**REGULAR MEETING OF THE THIRD LAGUNA HILLS MUTUAL
ARCHITECTURAL CONTROL AND STANDARDS COMMITTEE**

**Monday, February 26, 2018 – 9:30 a.m.
Laguna Woods Village Community Center Sycamore Room
24351 El Toro Road**

DATE: February 26, 2018
FOR: Architectural Control and Standards Committee
SUBJECT: Variance Request
Mr. and Mrs. Richard and Heidi Penkava of 3191-D (La Reina, PL804RA)
Replace Existing Enclosed Rear Patio with Room Addition

PROPOSE FLOOR PLAN

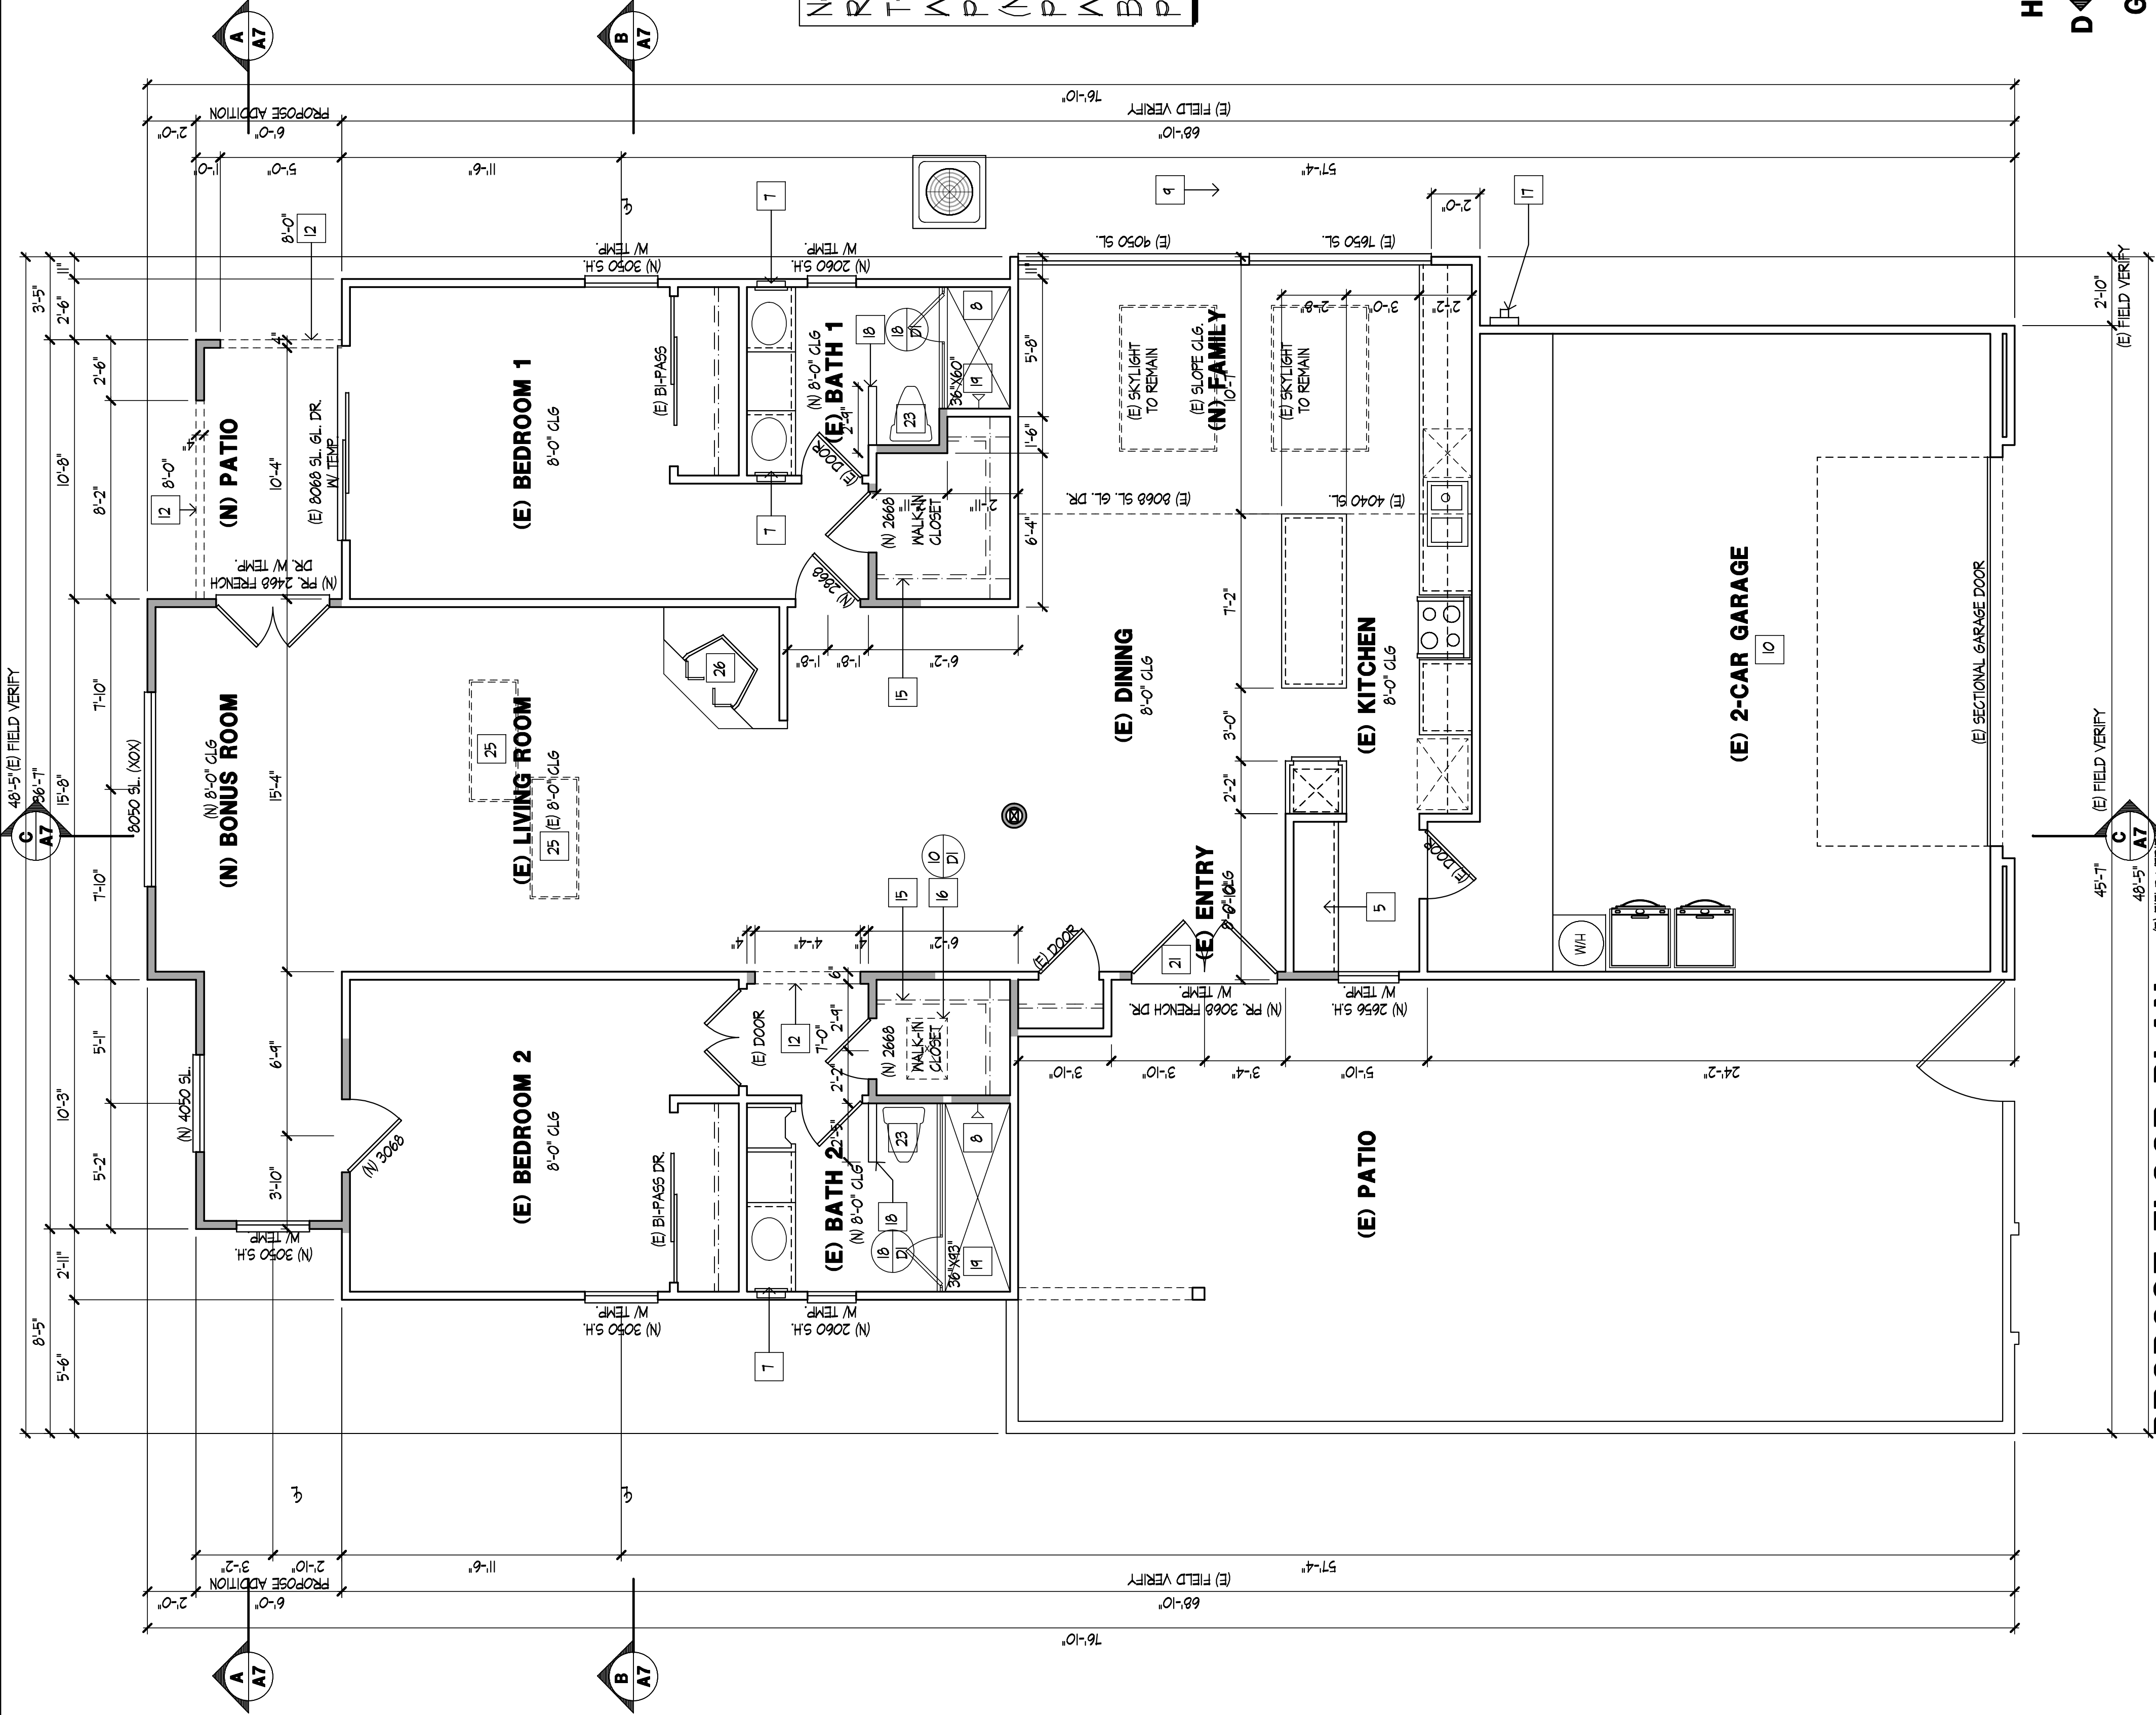
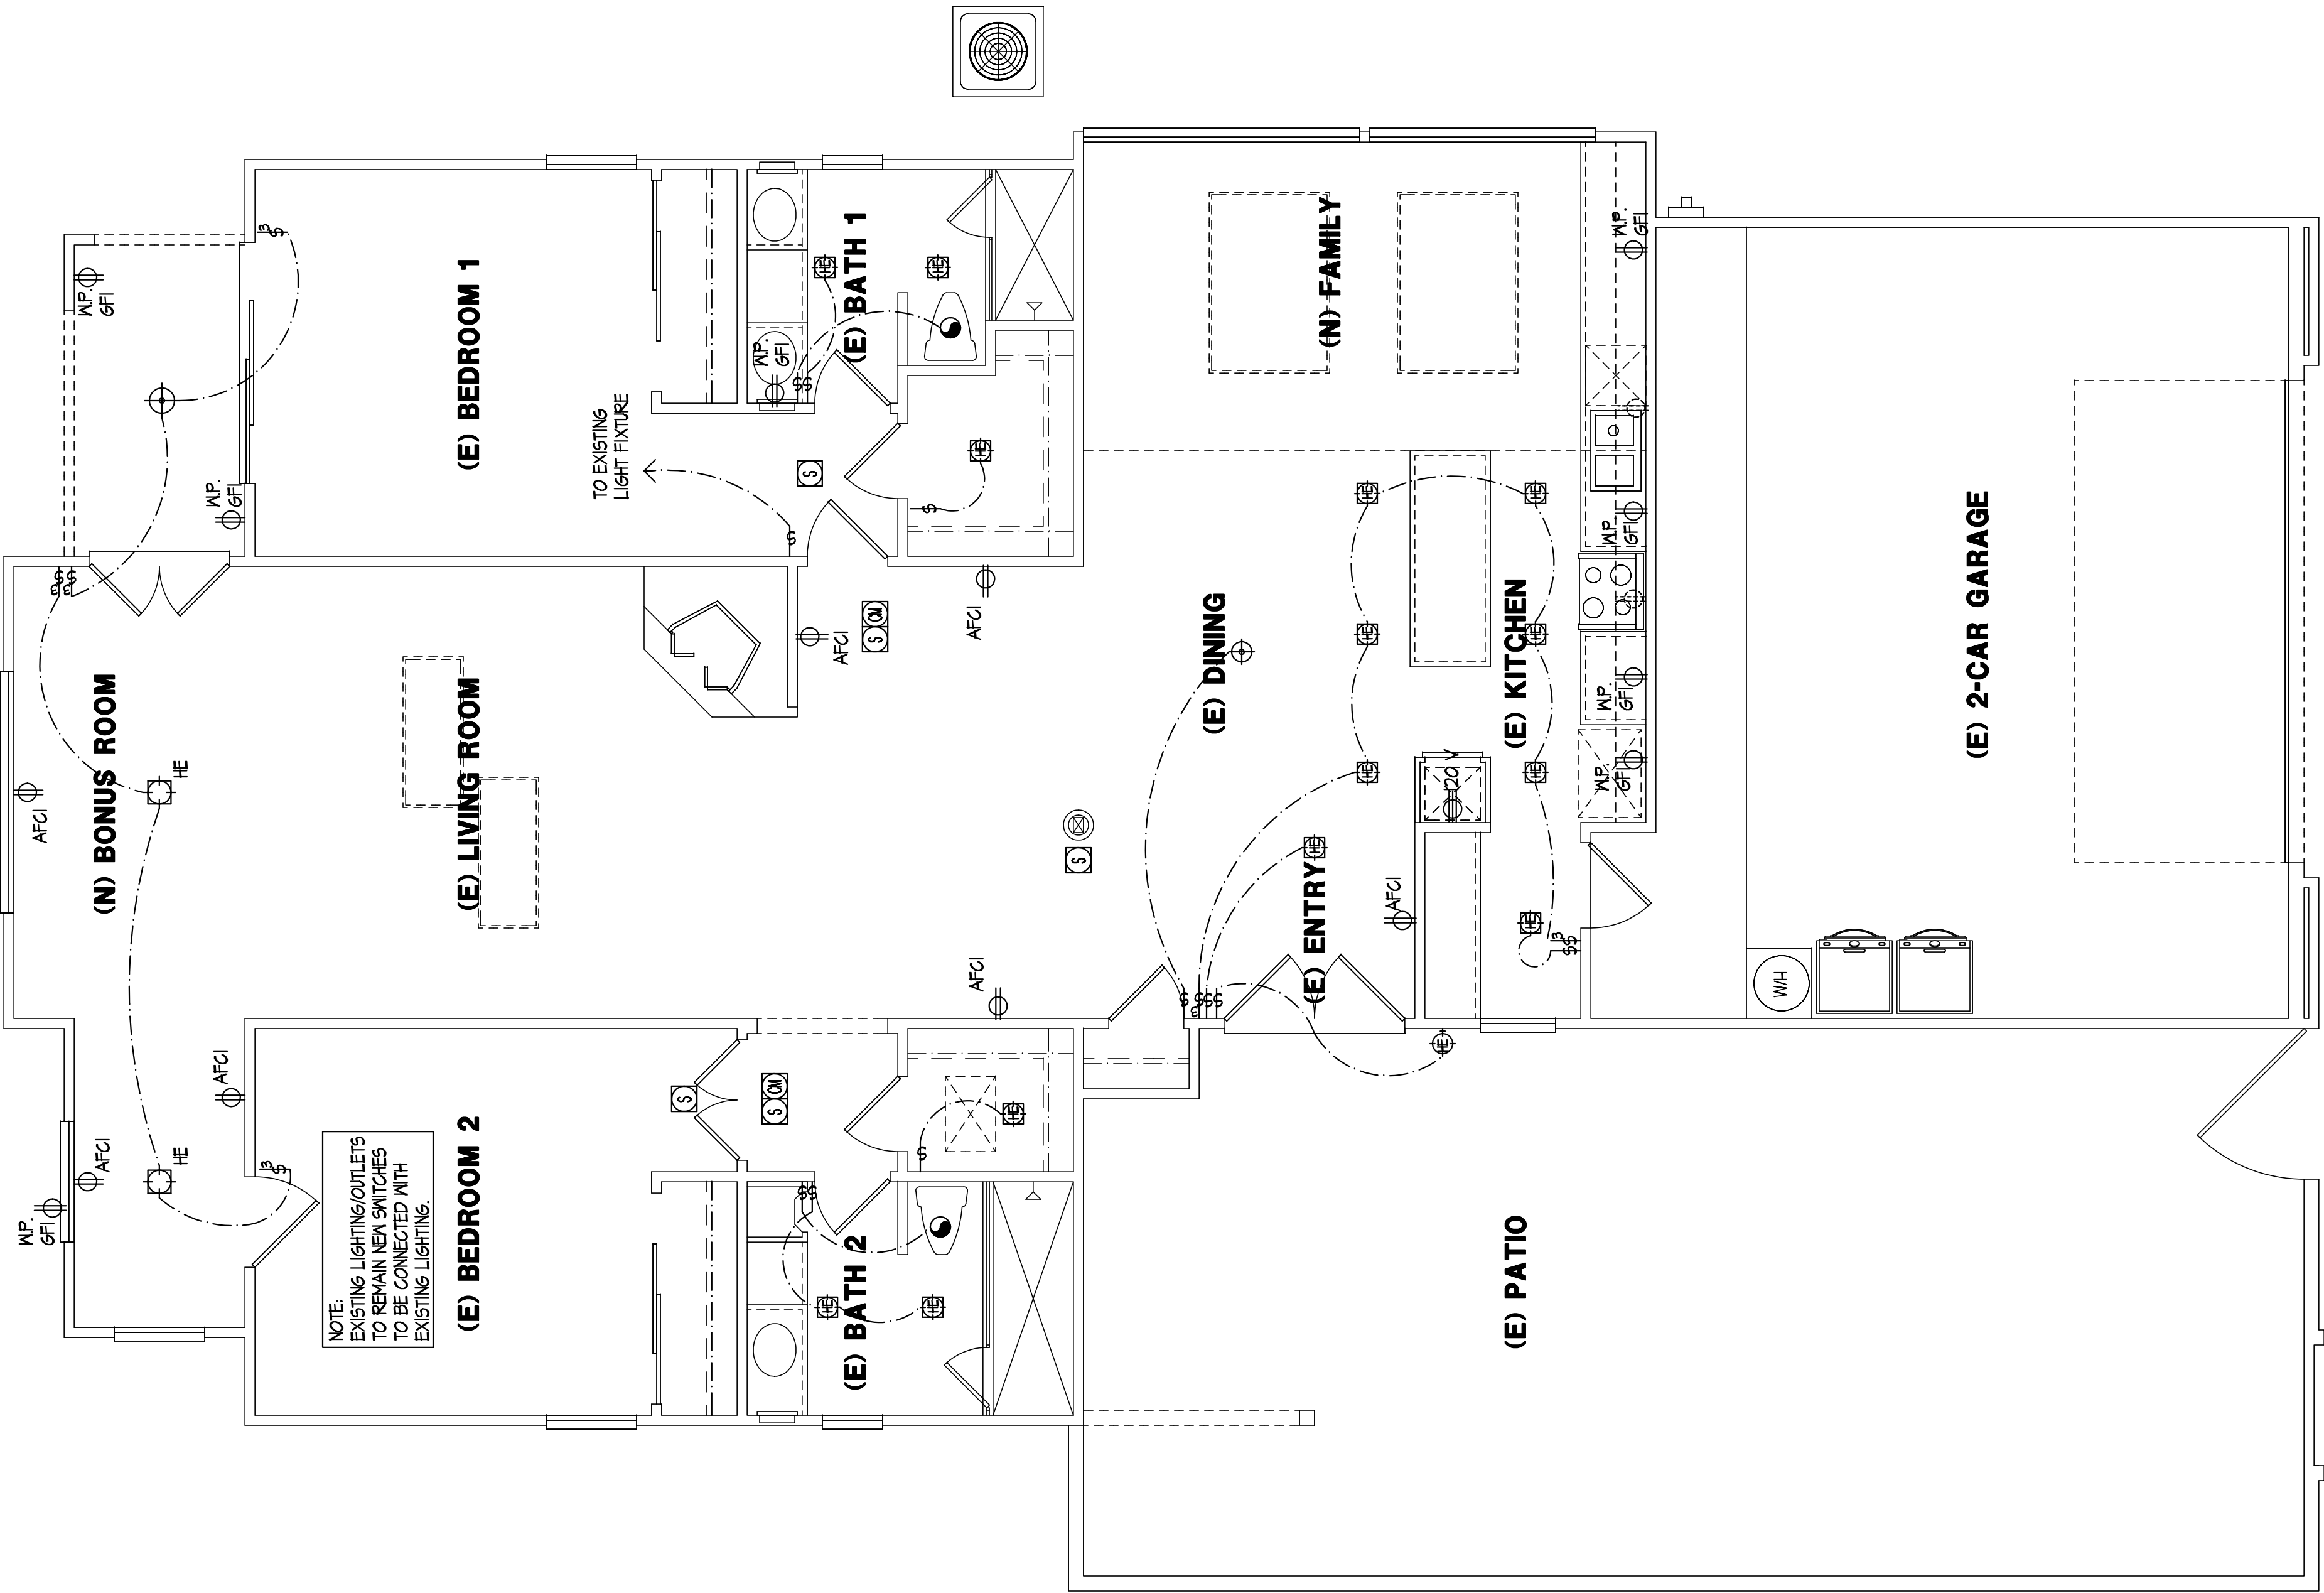
Mr. Reza Karimi of 5037 Avenida Del Sol, a Villa Reposa style manor, is requesting Board approval of a variance to construct a room addition and patio cover on the same footprint as the original patio shown on the building's condominium plan (see Attachment 1). The cost of the proposed alteration would be borne by the Member. The room addition would take place on Exclusive Use Common Area only.

There are no Architectural Standard Plans for a room addition with patio cover on this style of unit; a Variance is required.

2. A Mutual Consent for Manor Alterations has been granted at **5037** for **Room Addition and Patio Cover on Rear Patio**, subject to the attached plans stamped approved and is subject to the final inspection by the Division. Any variations to the approved attached plans are not allowed and could result in a stop work notice and/or severe fines to the Member.
